DEVELOPMENT REVIEW COMMITTEE (DRC) COMMENT REPORT

APPLICANT RESPONSES

INITIAL MEETING DATE: April 22, 2025
REISSUE DATE: May 16, 2025
APPLICANT: City of Fort Lauderdale
AGENT: Stephanie Toothaker, Esq., P.A.
PROJECT NAME: International Swimming Hall of Fame (ISHOF)
CASE NUMBER: UDP-S25010
REQUEST: Site Plan Level IV Request

ISHOF-WEST BUILDING

8. Sheet SP-101 (Site Plan):

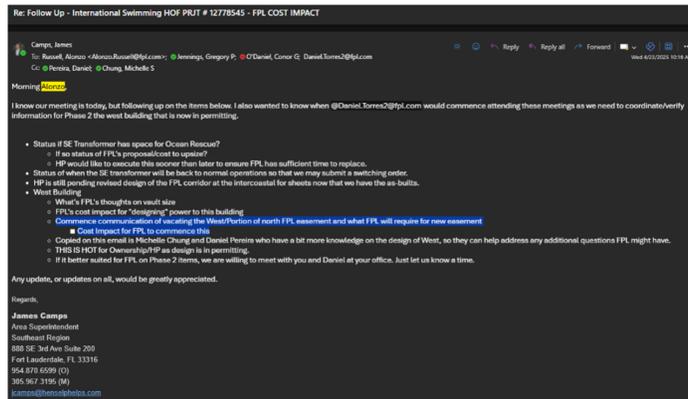
a. Delineate and callout all existing Florida Power & Light (FPL) easements in vicinity of ‘Proposed 6-Story Building’, including “18’ F.P.L. Easement per O.R.B. 12157, PG. 486, B.C.R.”, “10’ F.P.L. Easement per O.R.B. 27026, PG. 661”, and “Easement Area Permit #115940588”, as depicted on ‘Map of ALTA Survey’.

Response: Easements have been identified and called out on SP-101 per the Map of Alta Survey. Please see revised Sheet SP-101.

Snip from SP-101 Reflecting Portion of FPL Easement that is being coordinated to Vacated/Rerouted:

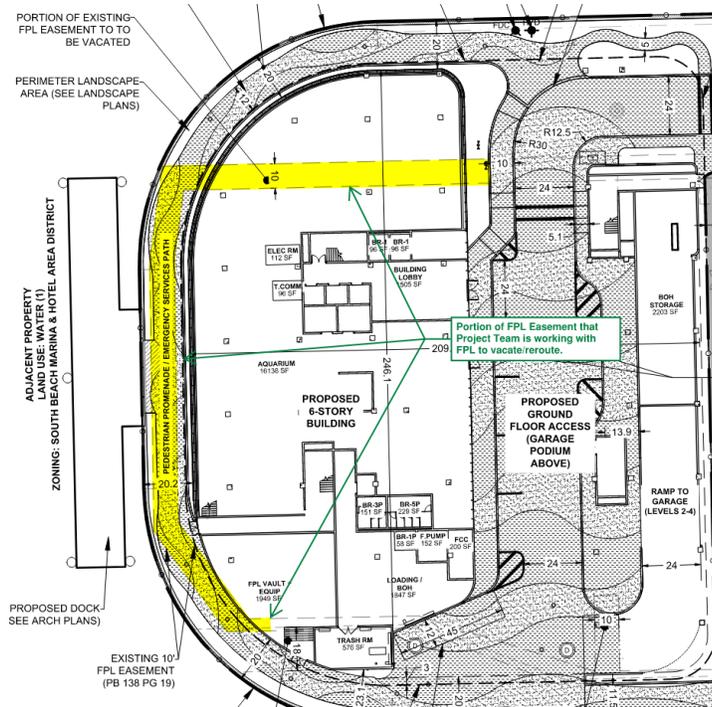
i. Regarding the ‘Portion of Existing FPL Easement to be Vacated’ callouts, show/label approximate limits of FPL easements to be vacated, and provide PDF copy of written correspondence from FPL staff that they have no objection to proposed vacations.

Response: HP has been in consistent communication with FPL on the potential of vacating a portion of the West and North easements on the west end of the peninsula, see attached image of email communication and marked up drawings. FPL is currently reviewing the loads for the future building as well as the revised pathways for their easement. Once this has been coordinated with FPL, the updated drawings will be reflected.
